T.I. no.: 2023-26 Updated: -	Topic: SCA NA - Overheating of boiler relays
---------------------------------	--

### Boiler overheating due to relay switching too late

Figure 1: Identification of the serial number, part number 075207 (partially assembled)

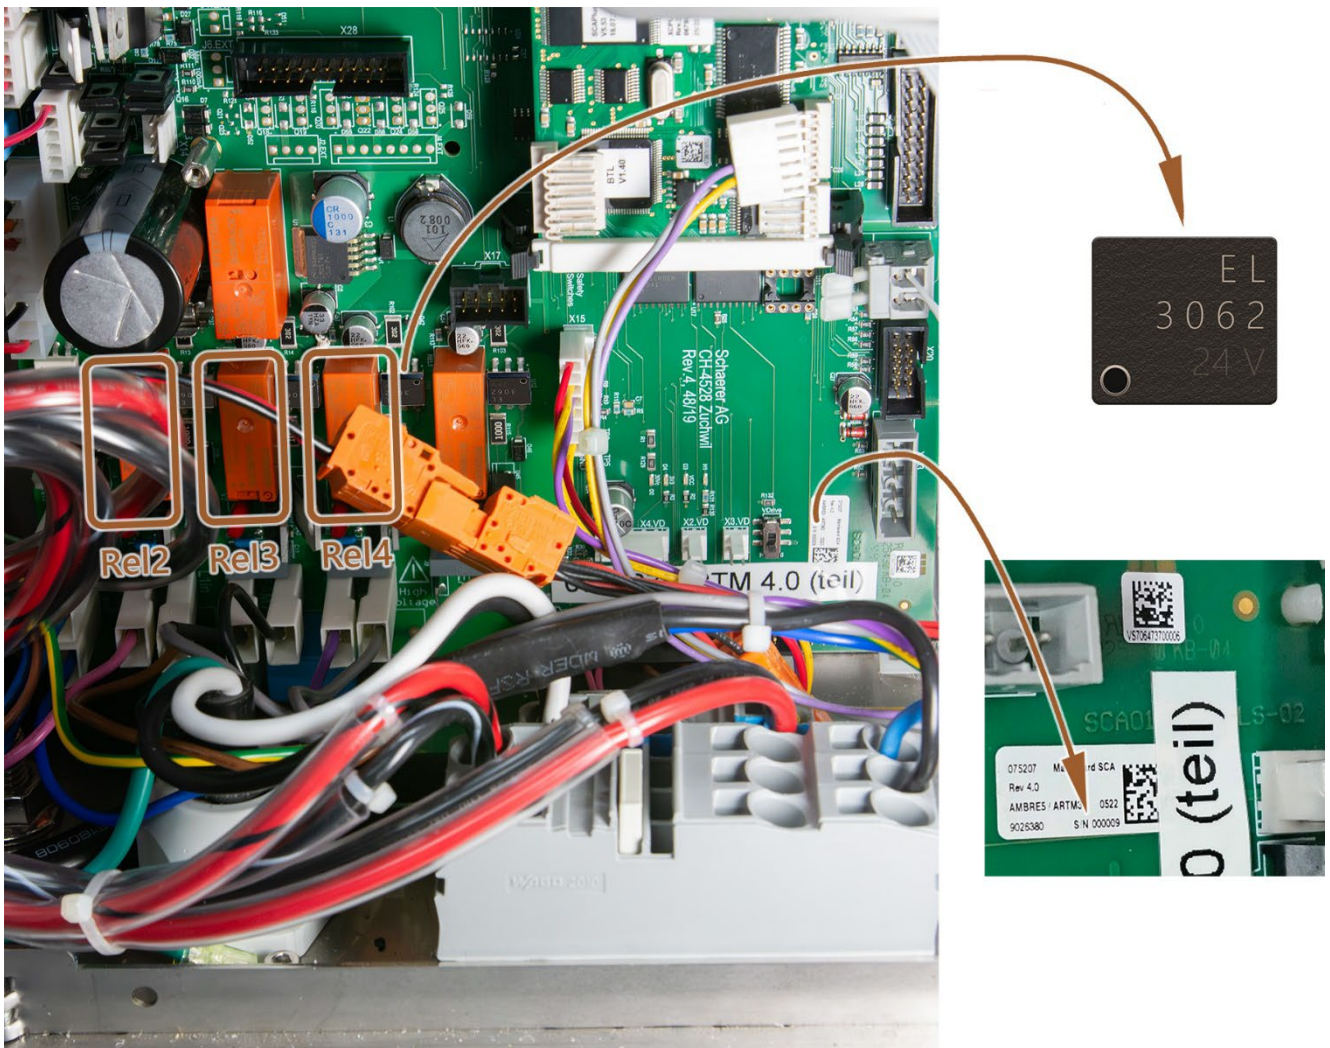
An opto-triac [EL 3062] from a second supplier, whose switching tolerance is somewhat higher than that of the first supplier, was used on the 075207 PC board on 580 machines between CW 42/2022 and 45/2022. This can cause opto-triacs U4, U5, U10 to switch downstream relays Rel2, Rel3, Rel4 with a delay. U12 and U41 are not affected.

This leads to light arcs between the relay contacts and to destruction of the relays; the downstream boilers are also activated for a period that is marginally too long. The heating elements overshoot and the safety thermostats trip.

### Distinguishing features: Serial number of the control PC board and type designation of the EL 3062 opto-triac

- ▶ Check the component identification number (EL 3062) of the opto-triacs.
- ▶ Check whether the serial number of the PC board is in the range of 007902 – 008491. The number is not easy to identify. Use the magnifying glass function on your smartphone if possible.
- ▶ Replace the power board. Spare part 075208 PC board SCA ARTM 4.0 fully assembled.

Not all opto-triacs from the second supplier are outside the required tolerance. We expect a total of 20% of the affected batch. The power board must always be replaced if one or more relays are damaged.
